## PORTSMOUTH MAPLE MASJID

### 686 MAPLEWOOD AVENUE

### TAC SUBMISSION PLAN

RE: Response to TAC Comments for Maple Masjid of Portsmouth, 686 Maplewood Ave

**SITE PLAN** **C2**

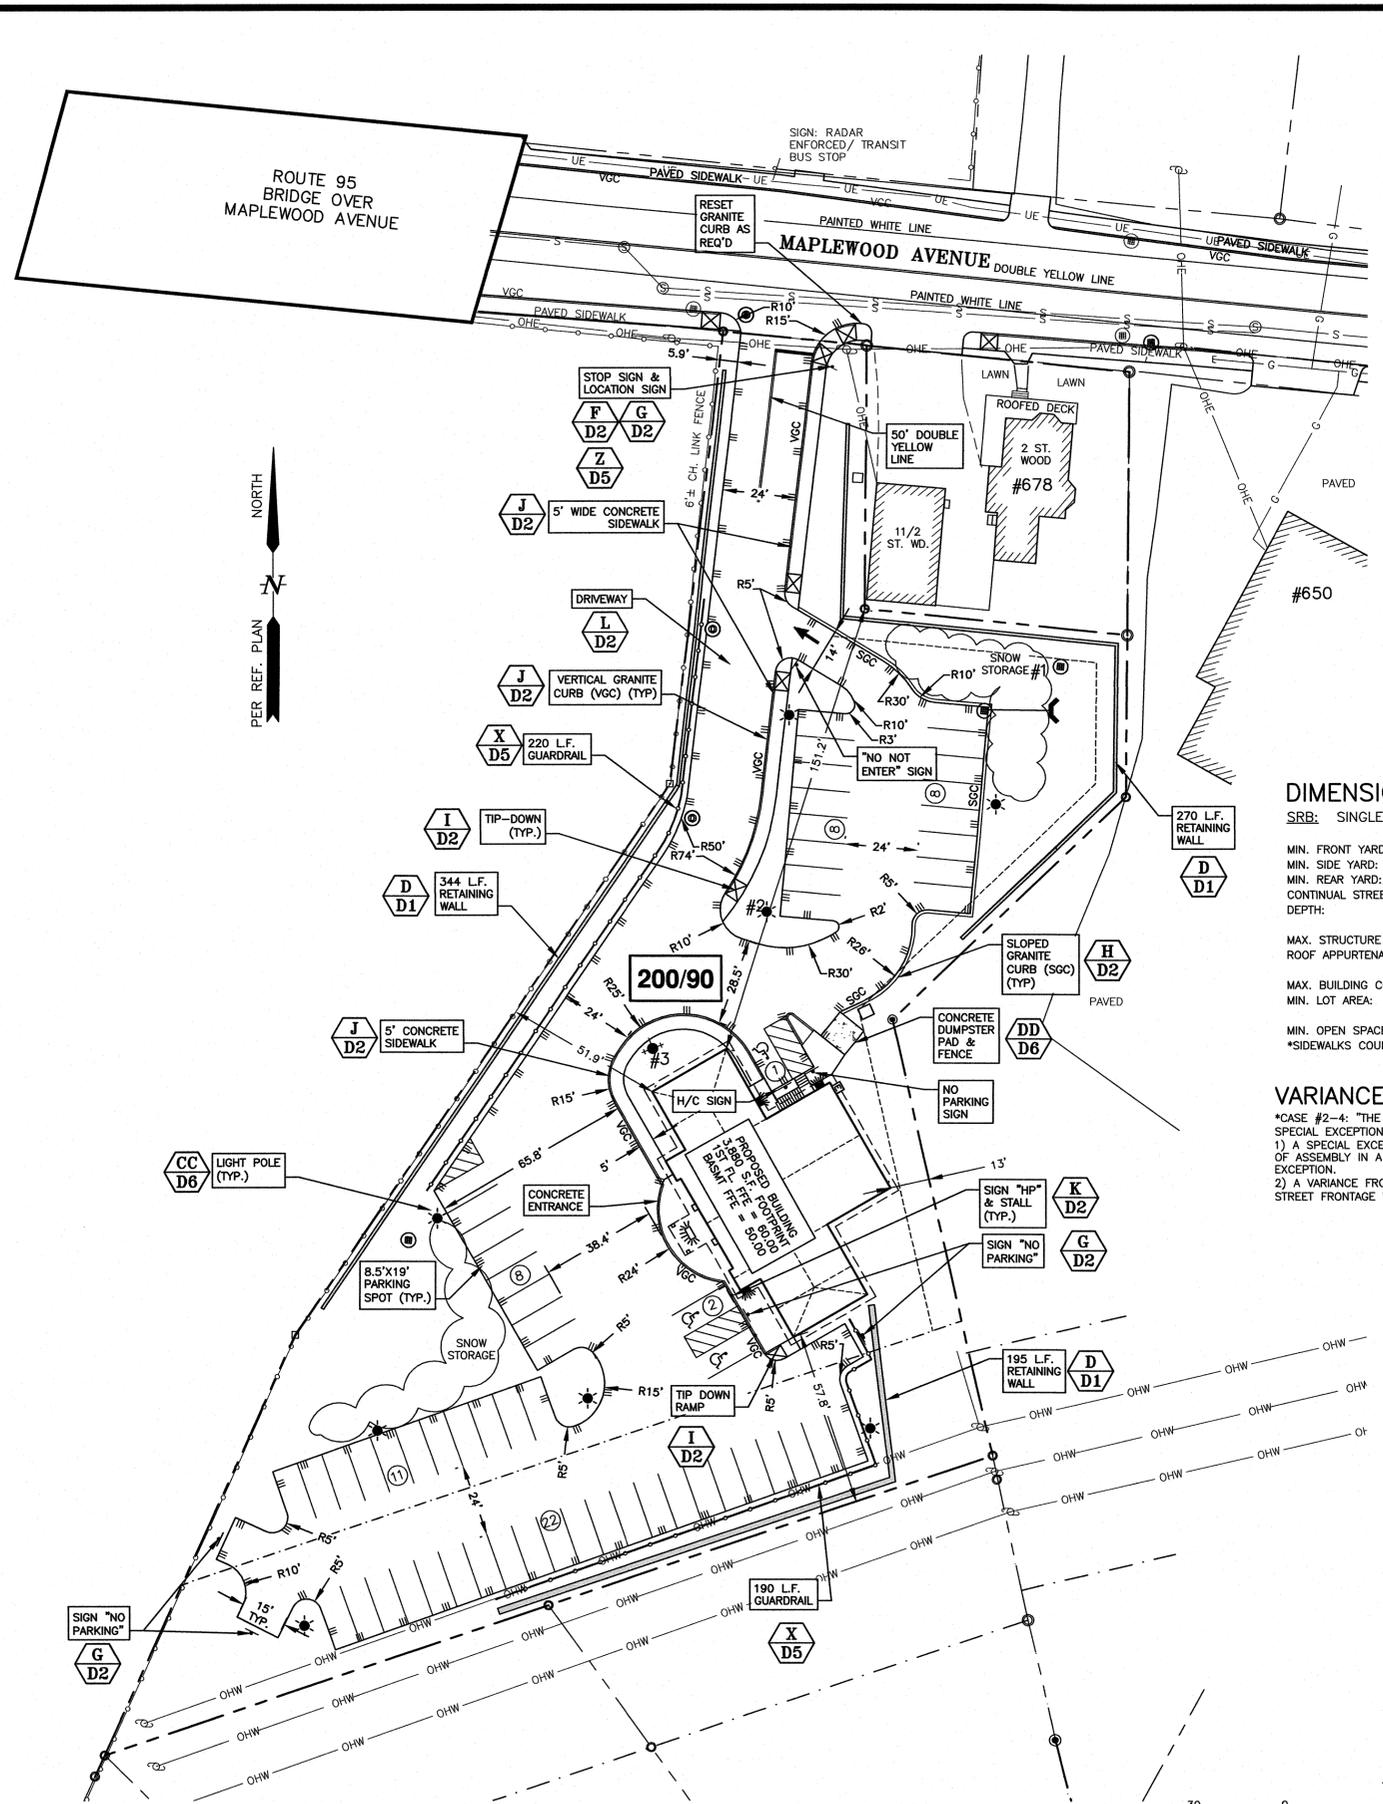
1. The 14-foot wide driveway into the parking area nearest Maplewood Ave is too narrow for 2-way traffic. It should either be widened to 16-feet or be one-way flow. **The driveway into the parking area nearest Maplewood Ave has been shown with a one-way flow arrow and a "Do Not Enter" sign. See Sheet C2.**

2. The handicap access aisles should have NO PARKING signs at the front of the space. **No Parking signs have been added to the design as requested. See Sheet C2.**

4. The driveway should have a 50-foot segment of double yellow center line at its intersection with Maplewood Ave, to help separate entering and exiting traffic. **A 50-foot segment of double yellow center line at the intersection of Maplewood Ave has been added to the design as requested. See Sheet C2.**

5. A sidewalk along the site driveway should be provided to connect to the sidewalk on Maplewood Ave. **A sidewalk has been added along the site driveway as requested. See Sheet C2.**

**UTILITY PLAN** **C3**

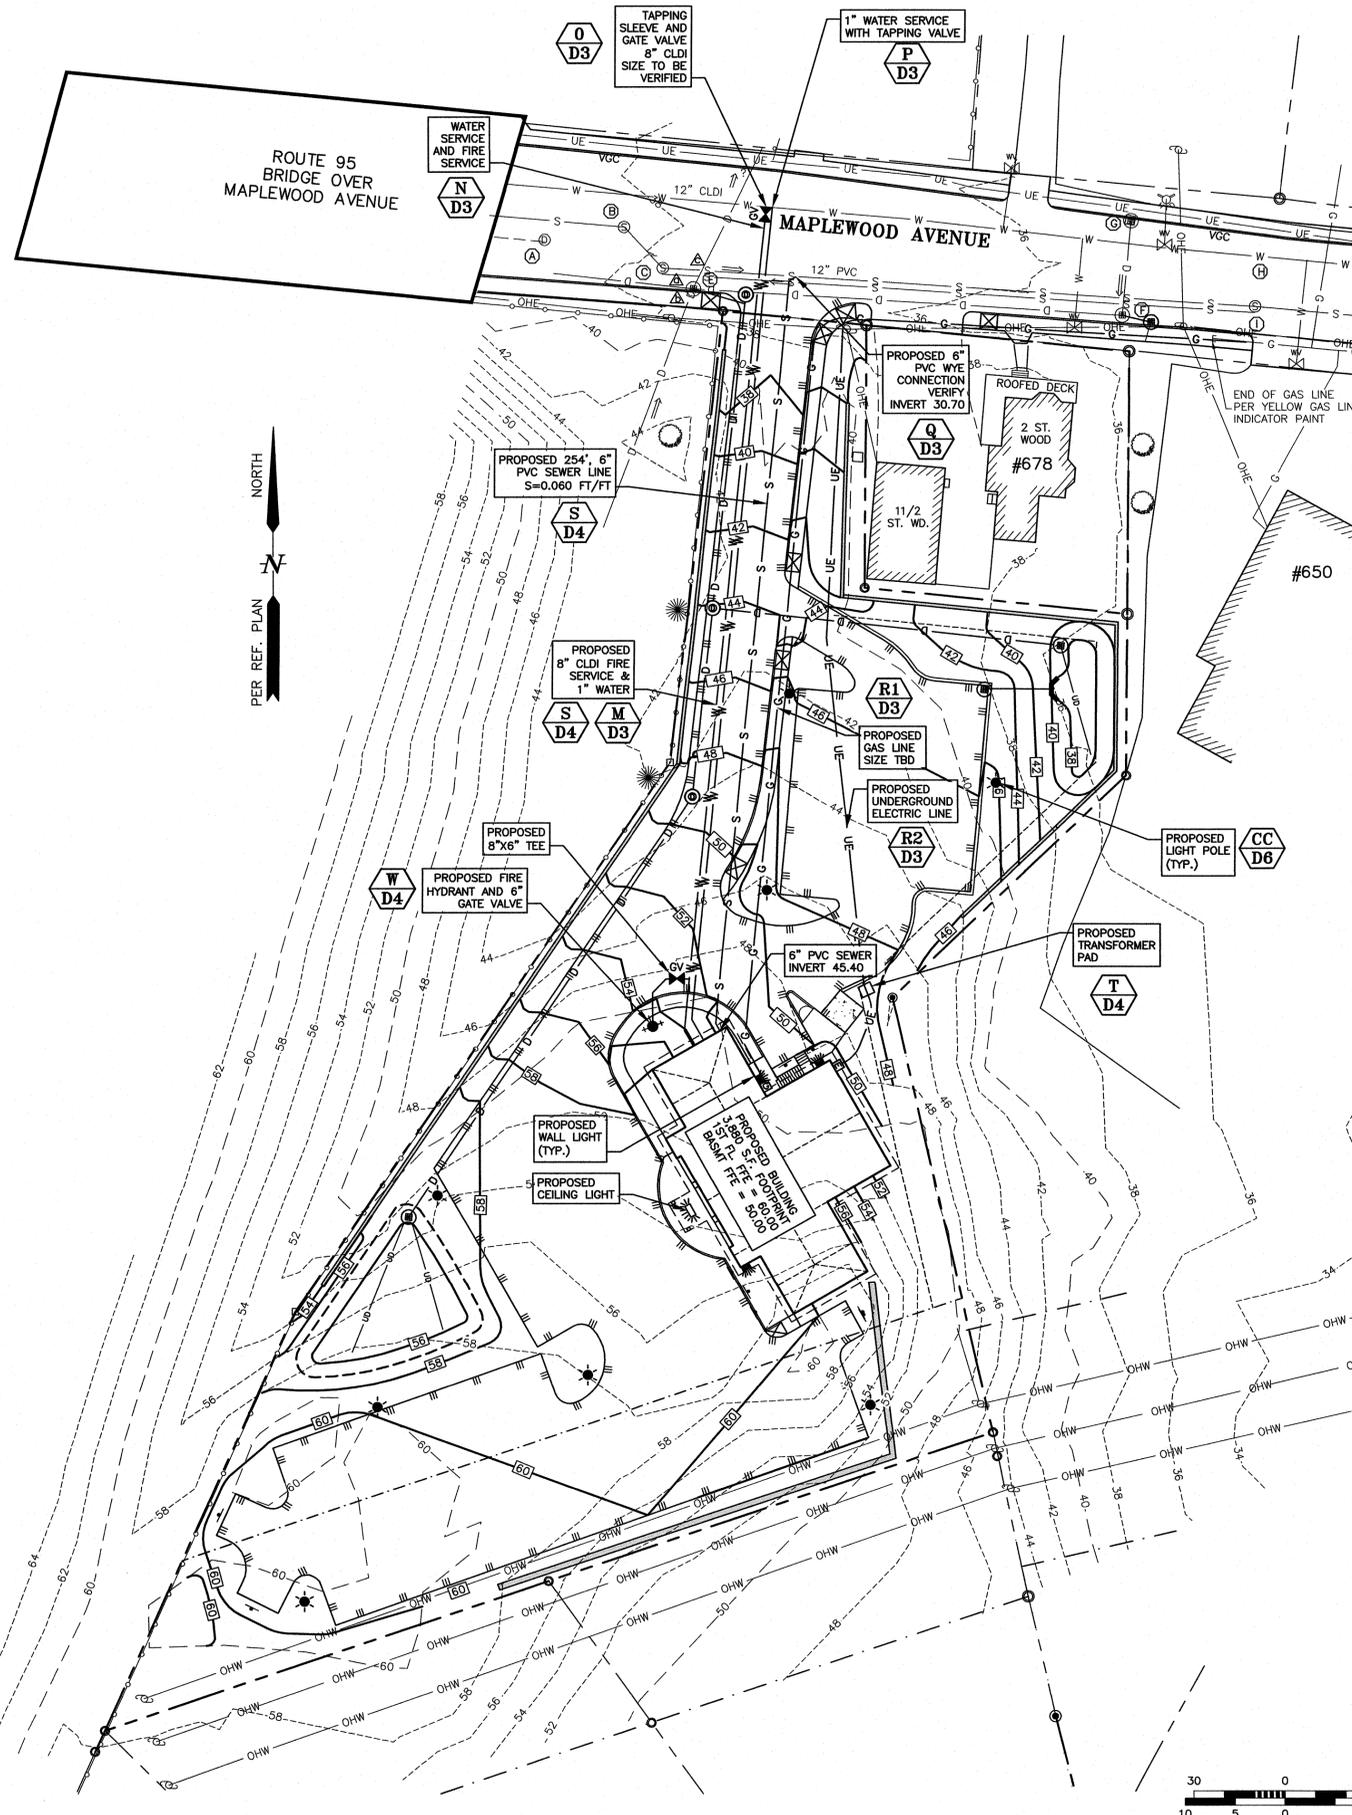
7. Yard fire hydrant should be added to the landscaped island on north side of building. Existing distance to the front door from the closest hydrant on Maplewood Ave is approximately 500'. Proposed fire service water line to be upgraded from 4" to 8" from Maplewood to the new hydrant. New hydrant to conform to Portsmouth Water Dept. standards. **The plan has been revised as requested and will conform to Portsmouth Water Department standards. See Sheet C3.**

14. Utility connections in Maplewood Ave shall be made at least 3 months prior to final overlay or a mill and fill will be required. **Note 6 has been added on sheet C3 that utility connections in Maplewood Avenue shall be made at least 3 months prior to final overlay or a mill and fill will be required.**

## D C2 BLOCK GRAVITY WALL DETAIL NTS

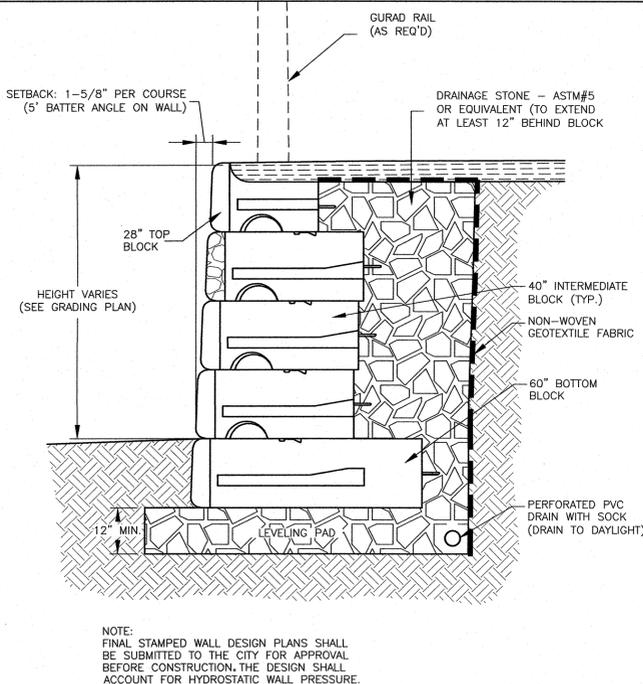
9. The applicant is showing storm drainage areas adjacent to retaining walls in two areas. These need to be detailed thoroughly to prevent hydraulic loading on the walls. **Detail D on Sheet D1 has been revised.**

**E1** FULL DEPTH PAVEMENT SECTION AND PAVEMENT JOINT DETAIL  
NTS

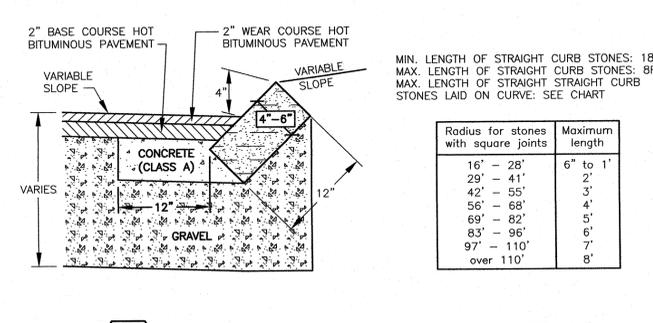
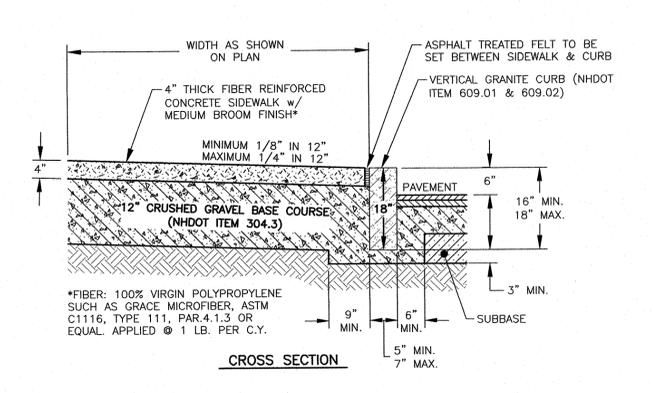
11. Applicant may want to change the pavement design to provide a sturdier pavement base. **Details E & L on Sheet D2 have been revised to include a 2 ½" wearing course and a 1 ½" binder course.**
